Response to Reviewer 1 Comments

Title: *Orphaned Oil & Gas Well Methane Emission Rates Quantified with Gaussian Plume Inversions of Ambient Observations*

Manuscript ID: *egusphere-2025-344*

Response to Reviewer 2 Comments

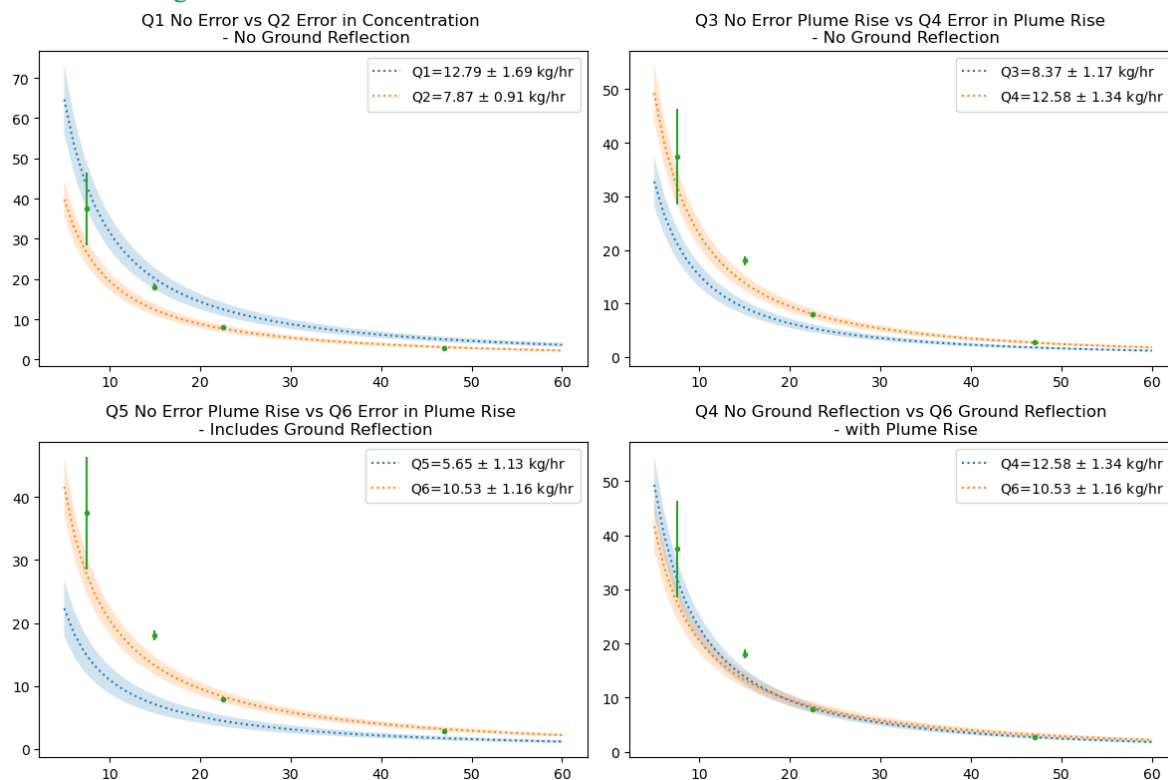
- Line 336: It would be useful to report the range of values/assumptions used for the error analysis.

To clarify, we ran several iterations of our Gaussian Plume model accounting for errors in the different parameters of the Gaussian plume equation (as shown in the figure below). We account for error based on measured concentration values, plume rise, and ground reflection. This is where we derive these estimates of 5.6 – 12.8 kg CH<sub>4</sub> h<sup>-1</sup>.

We have added the following text to clarify this statement:

“An error analysis was ran accounting for propagating errors in the model parameters of plume rise, ground reflectance, and the measured concentration of our empirically constrained dispersion Gaussian plume model. This error analysis resulted in estimates from 5.6 - 12.8 kg CH<sub>4</sub> h<sup>-1</sup> that is within –62% to + 42% of the directly measured leak of 9.0 ± 0.25 Kg CH<sub>4</sub> h<sup>-1</sup>.” (Line 339-342)

**Figure 1: Example of raw concentration data sampled at 1 Hz while the well was being vented demonstrating duration of periods of elevated CH<sub>4</sub>.**

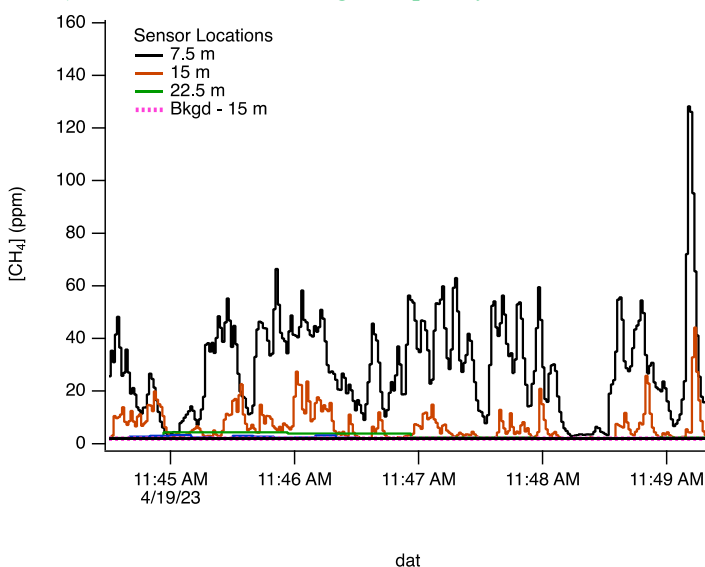
- Downwind distances – can authors elaborate on the details related to the design of the experiment, including (i) a discussion on the reason for selecting 7.5m, 15m, 22.5m, and 47m and selected downwind distances for monitors, (ii) employing measurement units from two different manufacturers, which may introduce a level of uncertainty, and (iii) the reason for deploying Aeris Pico at a height of 0.8m.

i) Sensor locations were chosen as a compromise between being far enough away from the methane source where the plume was broad enough for robust detection, but near enough to the source that dispersion did not diminish the signal. Figure 6 of our manuscript shows the broadening of plumes with respect to distance downwind.

We observed strong winds that varied little in direction and peaks in concentration typically lasted less than 1 minute (see figure with raw data below). There is not a simple metric for plume duration and concentrations are observed to fluctuate during the “in plume” measurement periods. Dispersion is due to several processes, including changing wind directions, turbulent mixing (changes in wind speed), and (minor) diffusion. These operate on different time/space scales. At 1 Hz sampling rate this meant the plume was only observed for <60 measurements with a smaller number at peak concentrations. In our analysis we averaged data over a 1-minute interval (section 3.1.1) which smooths out high frequency wind fluctuations.

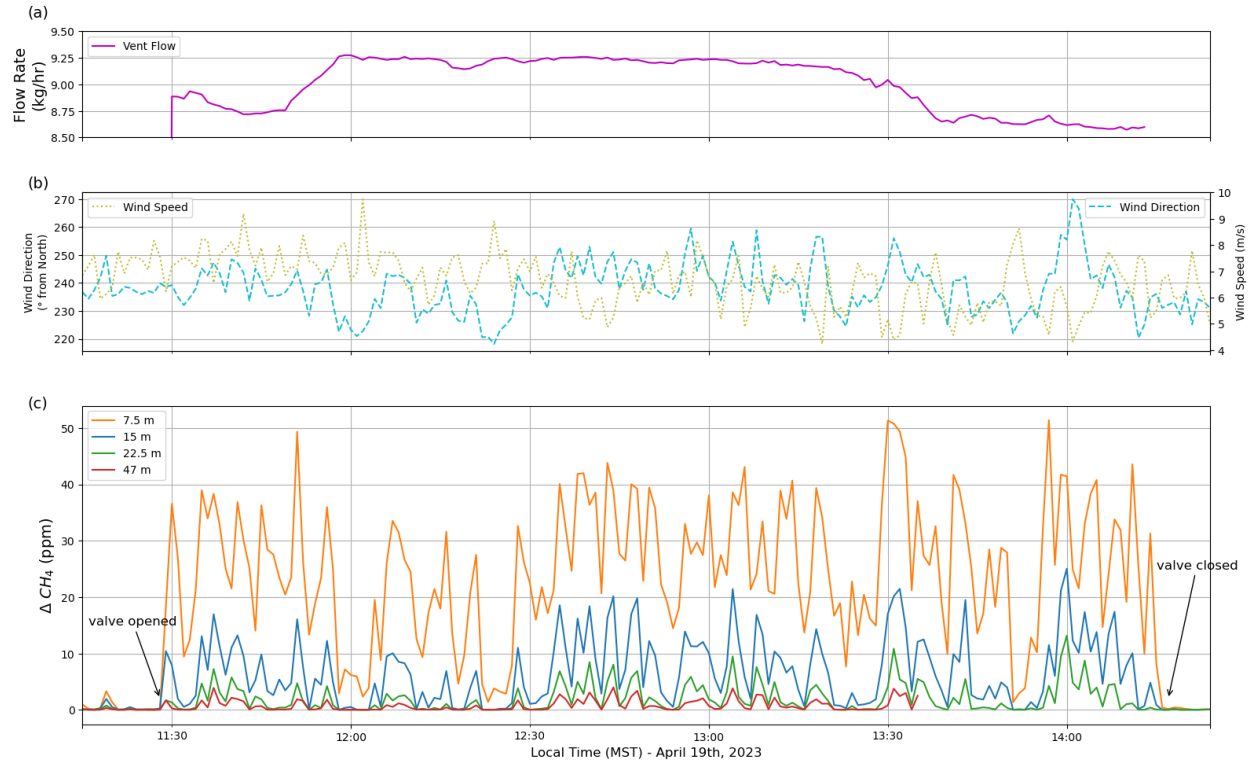
- Figure 4: The time axis does not appear to be in UTC, inconsistent with text.

- For Figure 10, can you please include timeseries of wind speed and wind direction, as well?

We have corrected the figure to represent the local time MST (Mountain Standard Time) and added parenthesis in the text clarifying the time in MST.

Yes, we agree this is valuable and have updated Figure 4(b) as well to include these.

**Figure 3: Comparison of model results to assess impact of accounting for different uncertainties and processes: a) uncertainty in excess CH<sub>4</sub>, b) impacts of assuming plume rise, c) uncertainty in excess CH<sub>4</sub> when assuming ground reflection, and d) impact of ground reflection.**

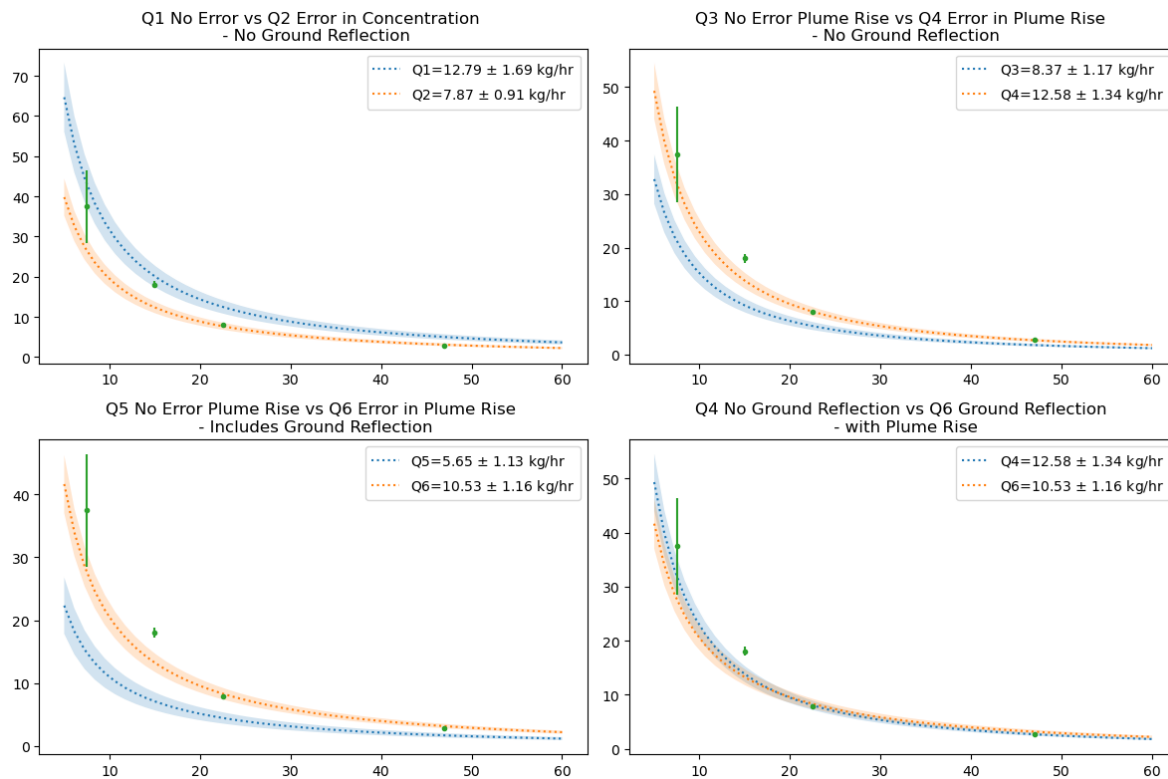
- Line 325: Please elaborate on the following statement “Other iterations of our empirically constrained dispersion model, where plume rise or ground reflection are excluded, result in estimates from 5.6 - 12.8 kg CH<sub>4</sub> h<sup>-1</sup>...”

We understand this was a bit confusing. This wording was meant to address the many iterations of the plume model (Equation 1) run by changing different parameters to understand the effects of plume rise, ground reflectance, plume spread, stability class, and more on the accuracy of the estimated methane flux (shown in Table 2 for one sensor, section 3.1.2 for stability class). We have updated the information in the manuscript (Line 339-342, text below).

Specifically, Gaussian plume models can be adapted to incorporate different processes and described on Line 287-189). In this manuscript we assume that a plume is transported downwind with a horizontal and vertical velocity measured by our sonic anemometers. Additionally, we assume that the plume cannot travel into the ground and account for this boundary condition by assuming the Gaussian shape is “reflected” from the ground surface (Section 18.9.1.1 Seinfeld & Pandis, 2016).

We ran several iterations of our Gaussian Plume model accounting for errors in the different parameters of the Gaussian plume equation (as shown in the figure below). We account for error based on concentration values, plume rise, and ground reflection. This is where we derive these estimates of 5.6 – 12.8 kg CH<sub>4</sub> h<sup>-1</sup>.

We have added the following text to clarify this statement:

“An error analysis was ran accounting for propagating errors in the model parameters of plume rise, ground reflectance, and the measured concentration of our empirically constrained dispersion Gaussian plume model. This error analysis resulted in estimates from 5.6 - 12.8 kg CH<sub>4</sub> h<sup>-1</sup> that is within –62% to + 42% of the directly measured leak of  $9.0 \pm 0.25$  kg CH<sub>4</sub> h<sup>-1</sup>.”
